**TITLE: FUSELAGE - REAR FUSELAGE - APPLY COLD WORKING AND
REPLACE RIVETS IN THE WASTE WATER SERVICE PANEL AREA AT
S18**

This page transmits Revision No.05 of Service Bulletin No.A320-53-1267

SERVICE BULLETIN No.: A320-53-1267

REVISION No.: 05 - Nov 29/16

Figure A-SBAAA - Sheet 01
Replacement of the solid rivets, FR65 to FR66

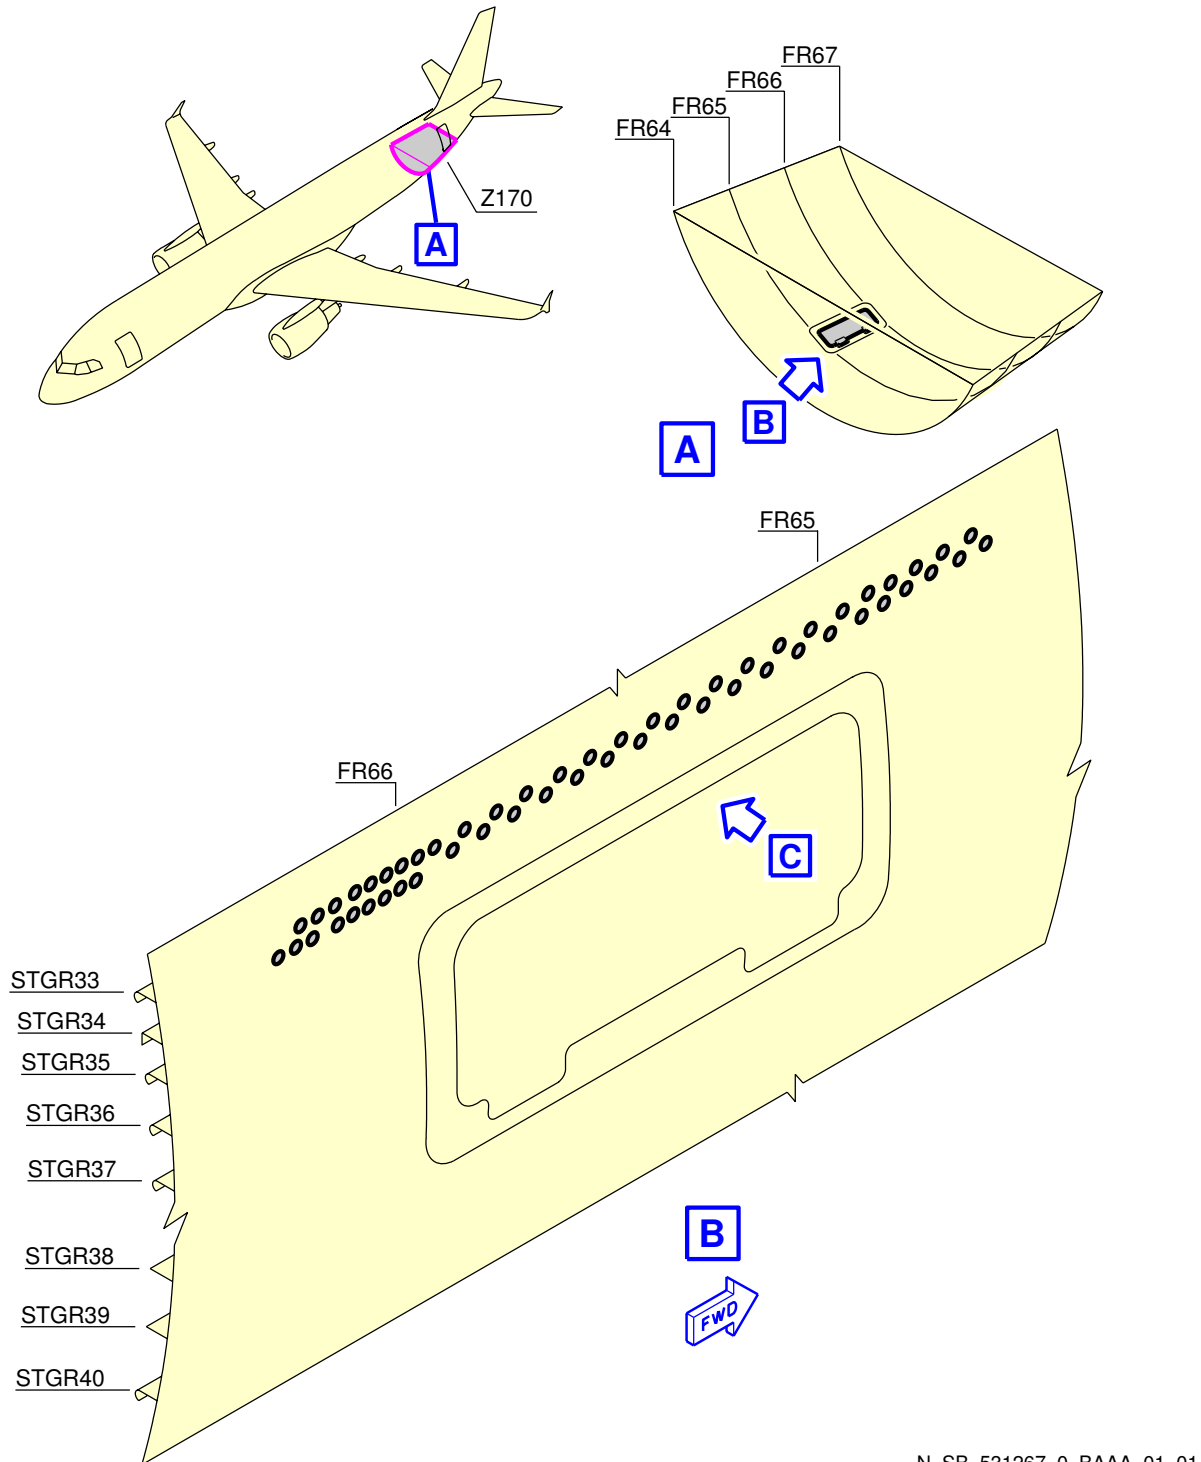
- (a) Remove the fasteners above the waste water service panel as shown on [Fig. A-SBAAA Sheet 01](#) and [Fig. A-SBAAA Sheet 02](#) and in accordance with SRM 51-42-00.

- (a) Do the cold expansion on the fastener holes as shown on [Fig. A-SBAAA Sheet 01](#) and [Fig. A-SBAAA Sheet 02](#) and in accordance with SRM 51-48-00 and SRM 51-44-00.

(b) Install the new fasteners as shown on [Fig. A-SBAAA Sheet 01](#) and [Fig. A-SBAAA Sheet 02](#) and in accordance with SRM 51-42-00 and refer to AMM Task 20-21-11-911-001:

Figure A-SBAAA - Sheet 02
Replacement of the solid rivets, FR65 to FR66

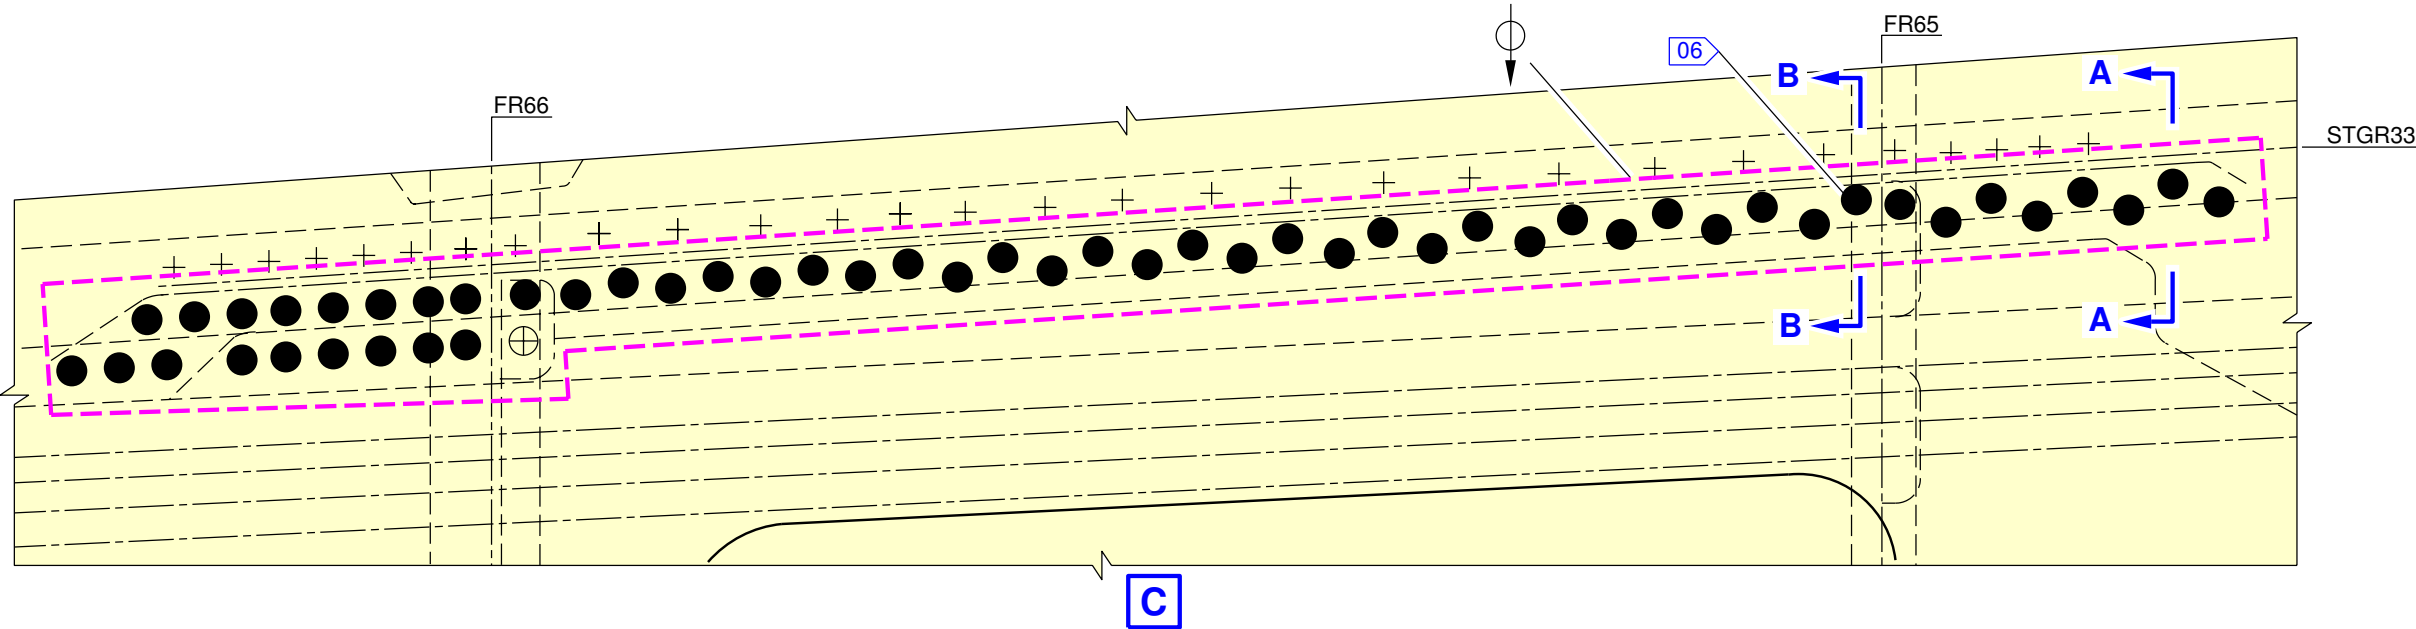
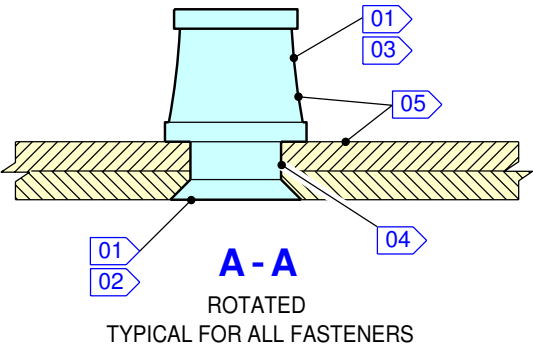
- 1 Oversize the holes to the starting hole diameter given in [Fig. A-SBAAA Sheet 02](#)

5 Remove the sleeves.6 Reams the holes to the final hole diameter given [Fig. A-SBAAA Sheet 02](#)

1 If during the installation of the affected fastener, as shown on [Fig. A-SBAAA Sheet 02](#), View C and [Fig. A-SBAAA Sheet 03](#), Section B-B, you find mechanical interference of the tightening tool or the fastener itself with the frame clip:

Figure A-SBAAA - Sheet 03
Replacement of the solid rivets, FR65 to FR66

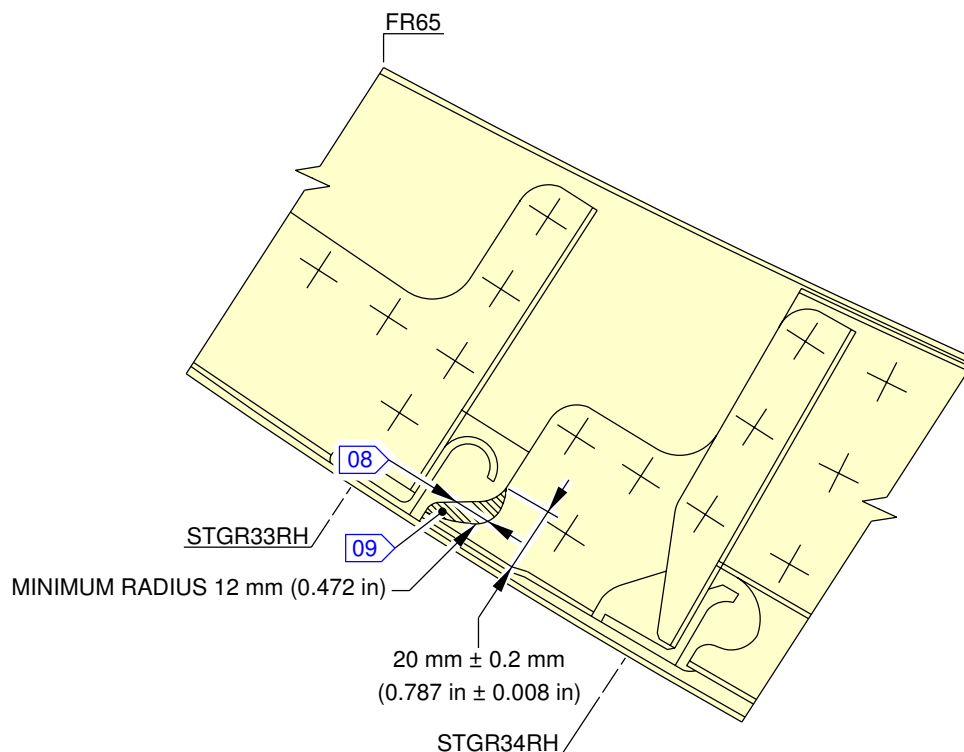
- a** Rework the frame clip as shown on [Fig. A-SBAAA Sheet 03](#).
- b** Ensure as much smoothness as possible on the trimmed contour.
- c** Deburr the sharp edges.
- d** Clean the reworked areas with:
